# HISTORIC AND DESIGN REVIEW COMMISSION

**HDRC CASE NO:** 2019-149  
**COMMON NAME:** W RHAPSODY DR NEAR WEST AVE  
**LEGAL DESCRIPTION:** NCB 17261 BLK 2 LOT 24 (PK SUBD)  
**ZONING:** I-1  
**CITY COUNCIL DIST.:** 9  
**APPLICANT:** Cory Hawkins/Beaty Palmer Architects  
**OWNER:** City of San Antonio  
**TYPE OF WORK:** Construction of a senior center  
**APPLICATION RECEIVED:** March 15, 2019  
**60-DAY REVIEW:** May 14, 2019  
**CASE MANAGER:** Stephanie Phillips  
**REQUEST:**

The applicant is requesting conceptual approval to construct a 25,400 square foot city senior center to service Council District 9.

**SITE PLAN**  
 true north 0' 15' 30' 60'

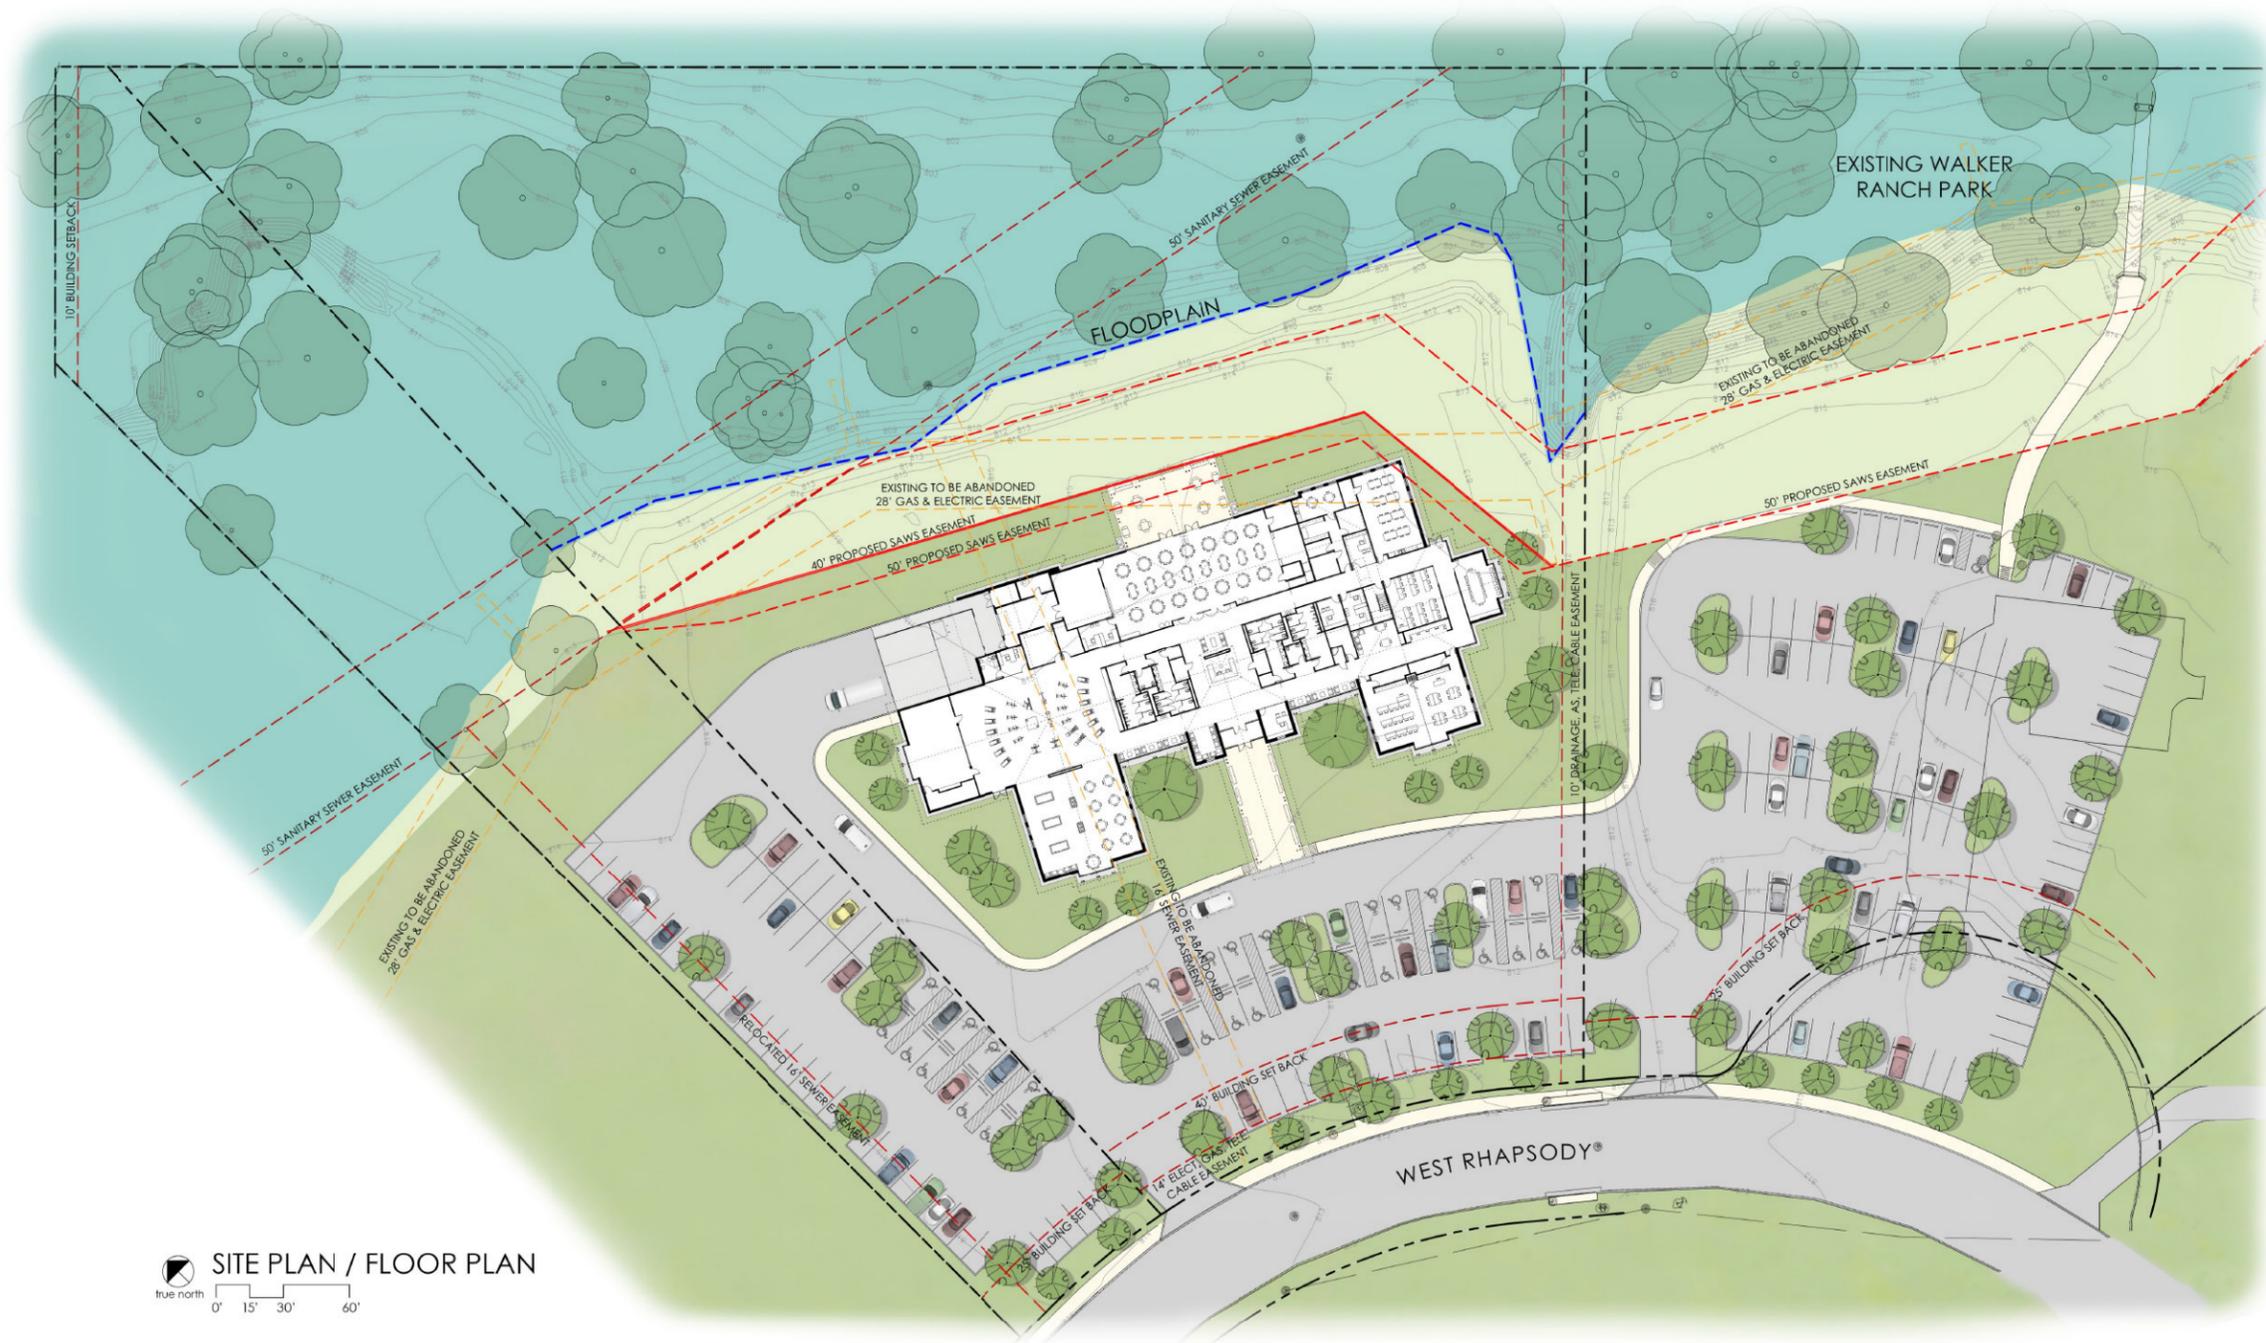
- d. MECHANICAL EQUIPMENT – The applicant is responsible for screening all mechanical equipment in conformance with UDC Section 35-642(b)(6).
- e. HARDSCAPING AND PARKING – The applicant has proposed several hardscaping elements as part of this project, including two driveways and a parking lot fronting W Rhapsody. The parking lot will include spaces for 202 cars, including 38 handicap accessible spaces and 30 oversized spaces for mobility constraints. Staff finds the proposal consistent with the UDC. The applicant is responsible for complying with UDC standards for screening and landscaping as noted in finding f.

- f. LANDSCAPING – According to the UDC, parking areas should be screened from view from the public right-of-way and should feature attractive fences, berms, plantings, or other means appropriate to the site. Per the submitted conceptual site plan, several trees and other landscaping elements will be incorporated onto the site. Staff finds this generally consistent with the UDC but requires a final landscaping plan indicating the location and species of all proposed plantings. The front parking lot should be significantly screened from W Rhapsody to best meet the UDC requirements.
